PRELIMINARY/FINAL DRAINAGE REPORT

JACKSON OFFICE WAREHOUSE & STORAGE BUILDINGS DEVELOPMENT ROCKY MOUNTAIN INDUSTRIAL PARK FILING NO. 1A, LOT 2

PCD File No. PPR-17-057

Markup Summary

JACKSON OFFICE WAREHOUSE & STORAGE BLDGS
8140 SANDY COURT
EL PASO COUNTY, COLORADO
EXIST & DEVELOPED DRAINAGE PLAN

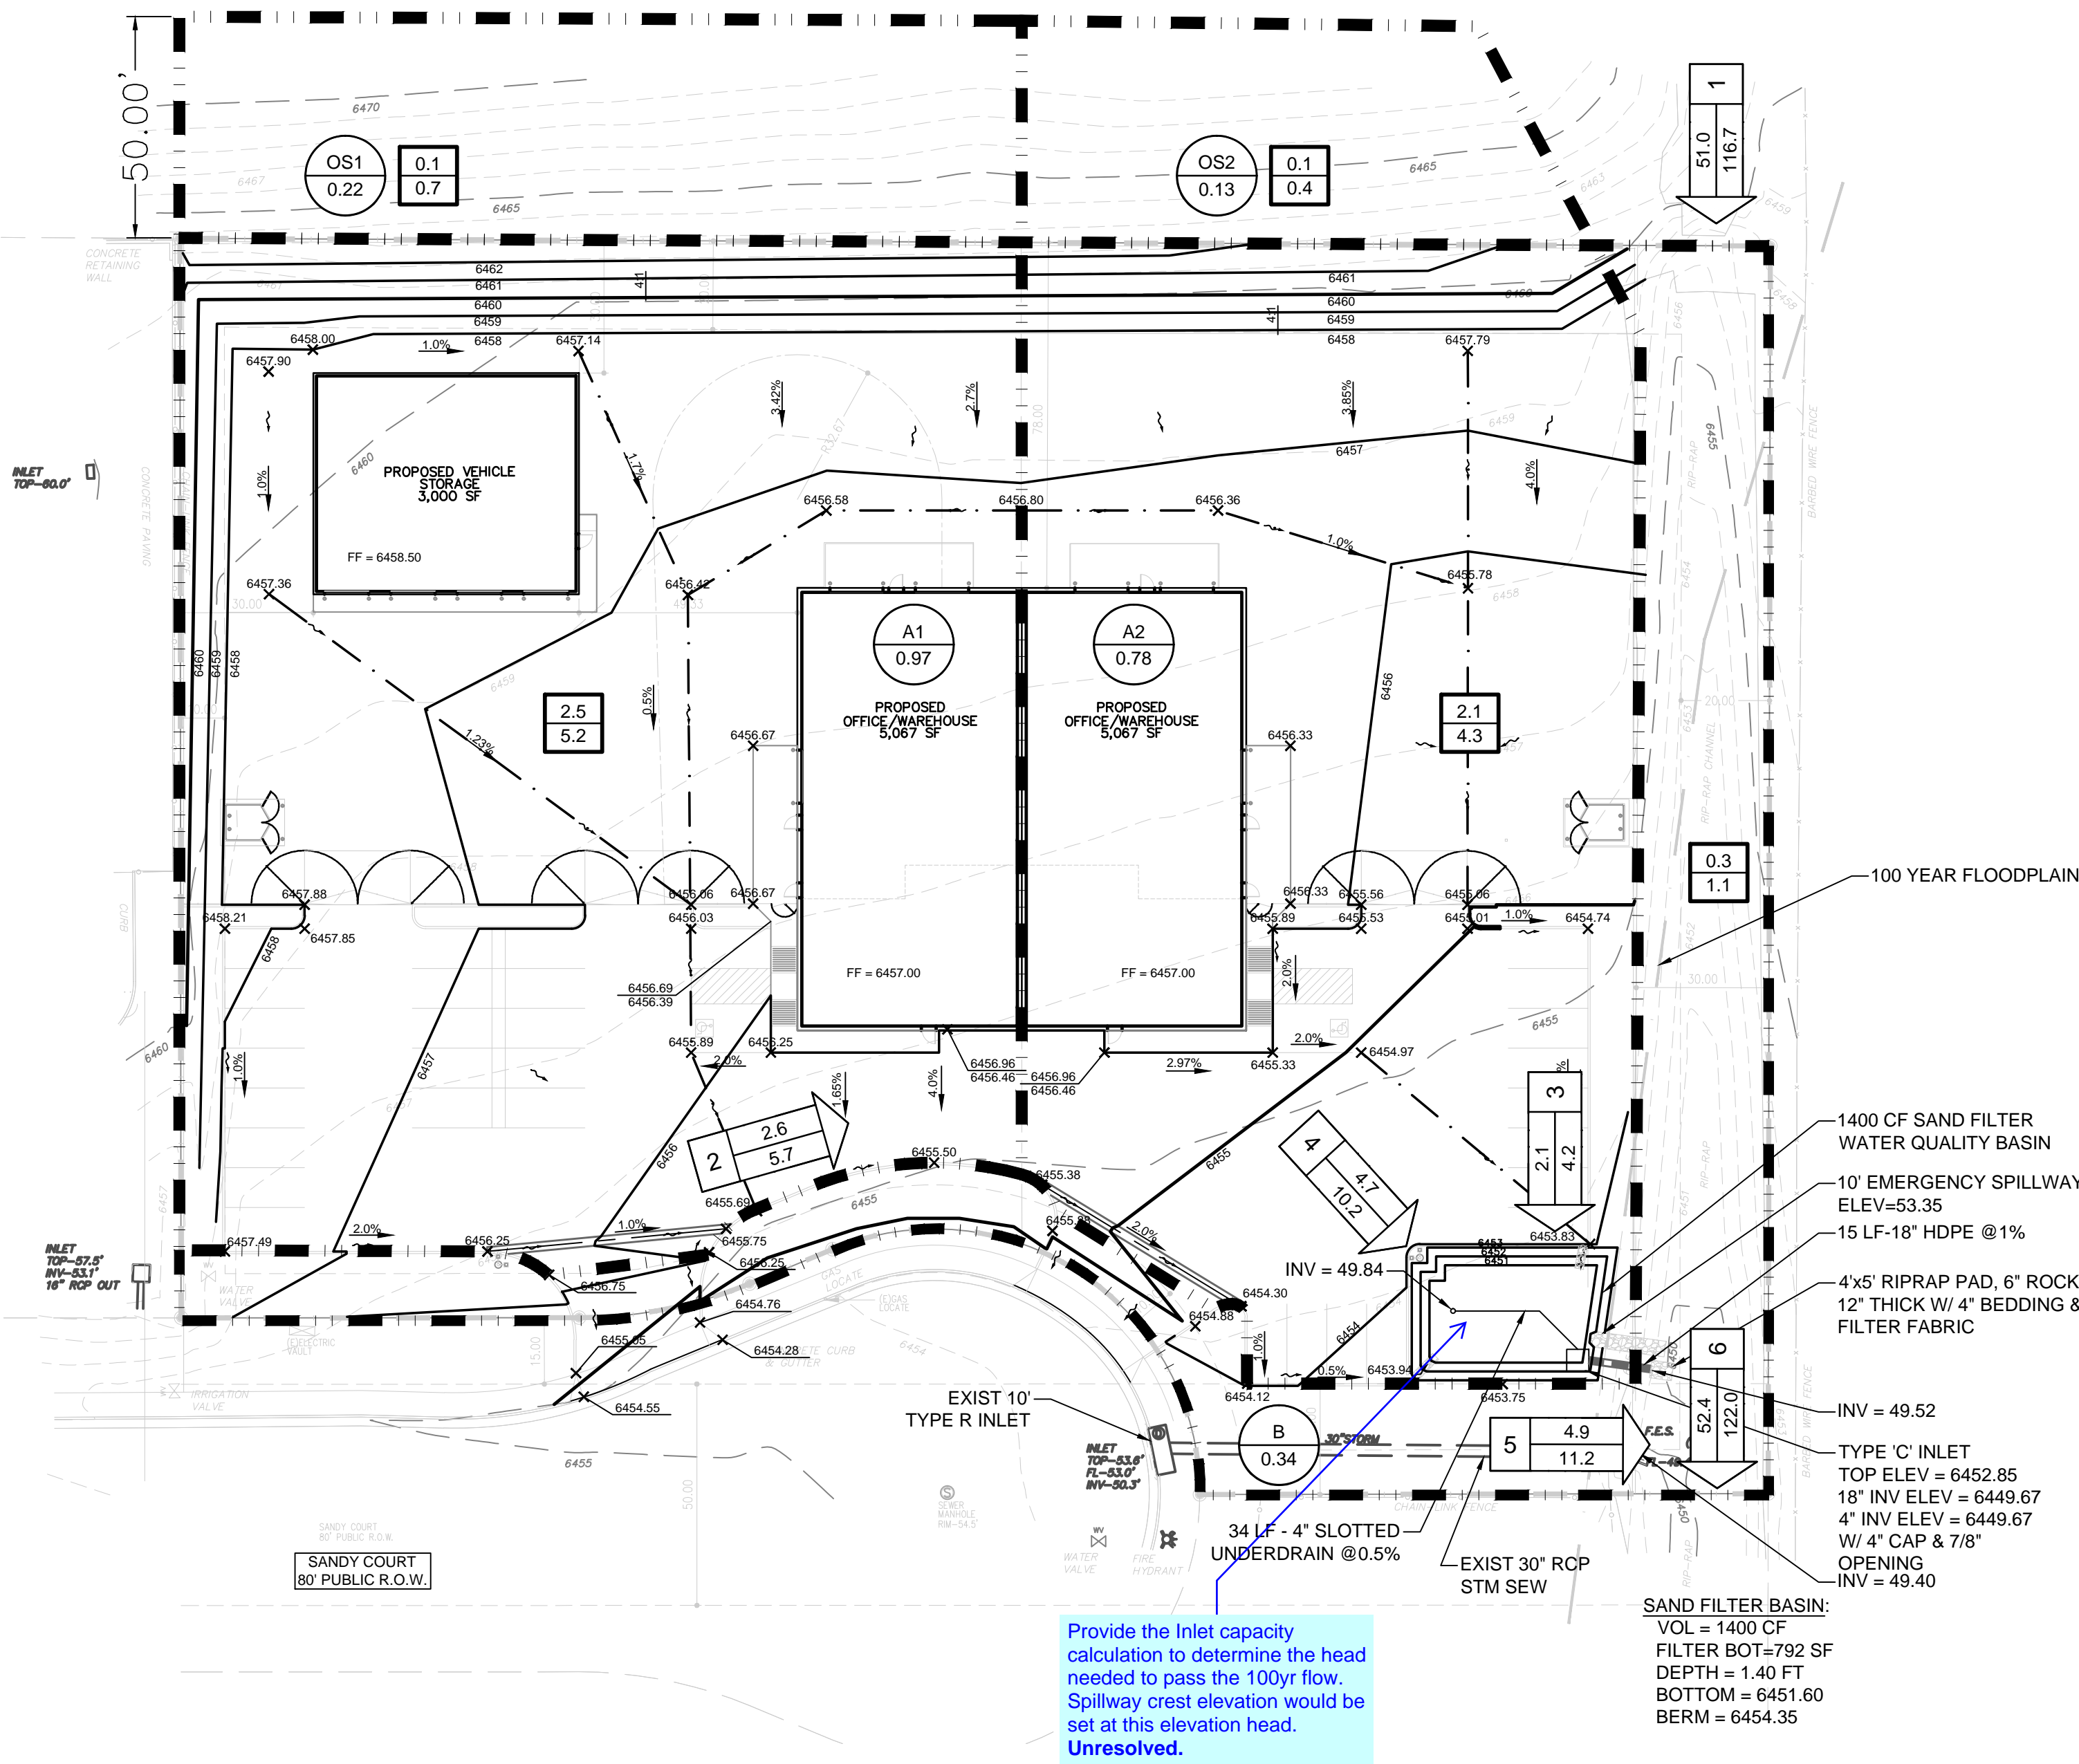
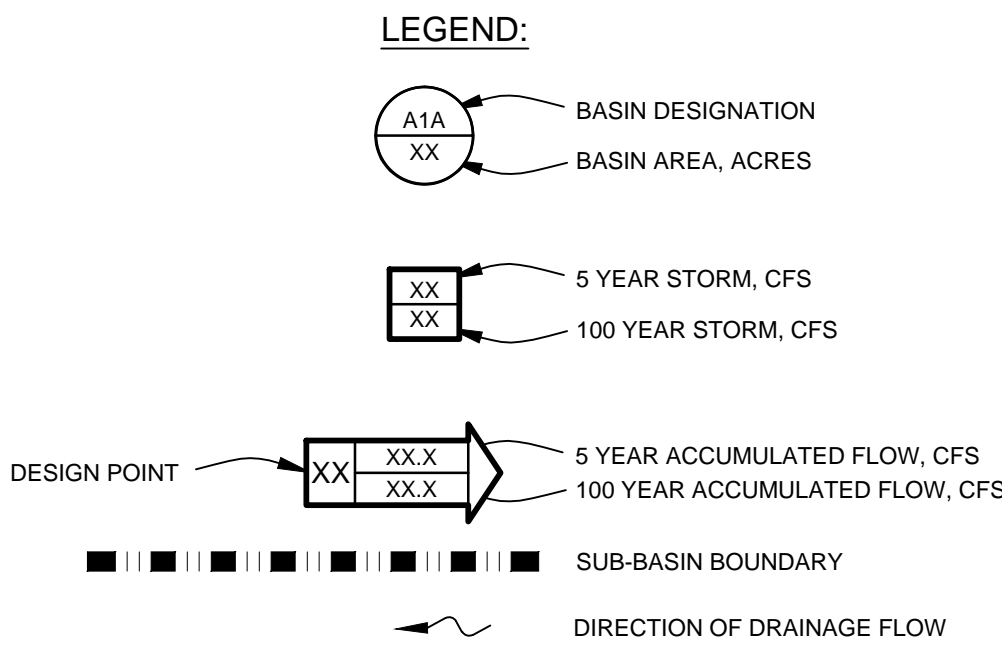
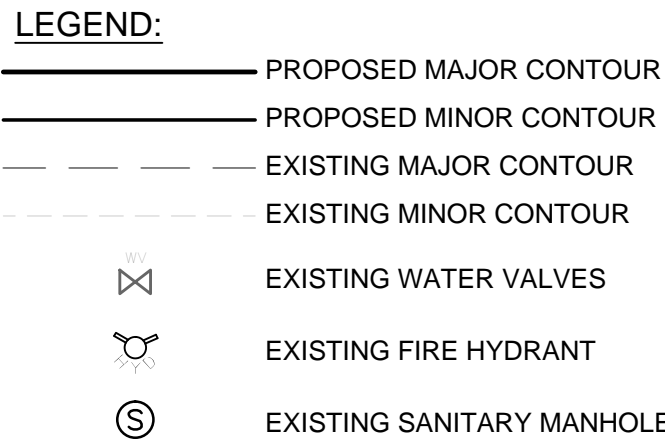
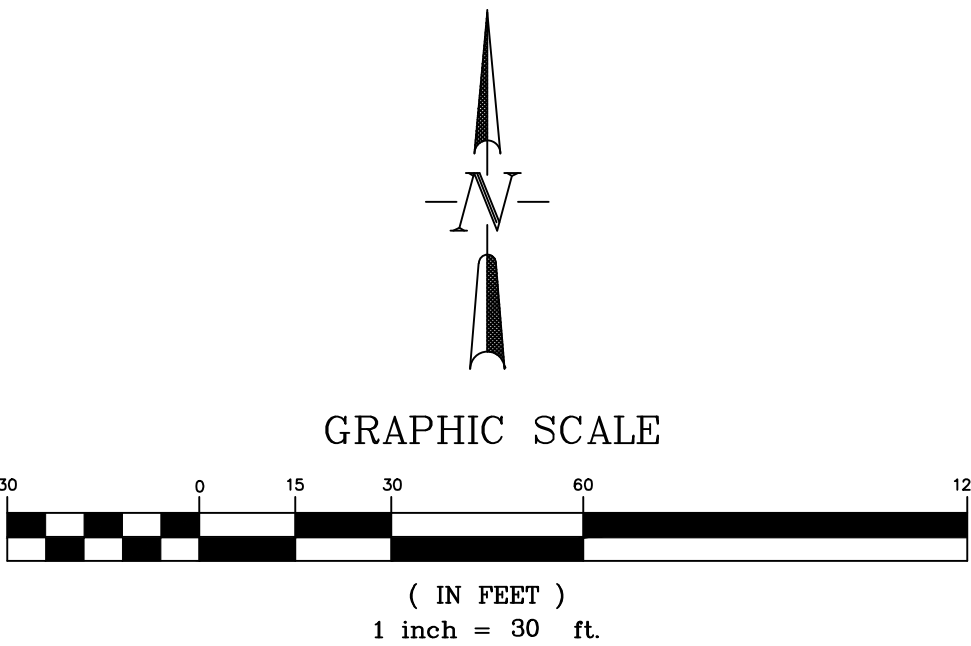
Provide the Inlet capacity calculation to determine the head needed to pass the 100yr flow. Spillway crest elevation would be set at this elevation head. Unresolved.
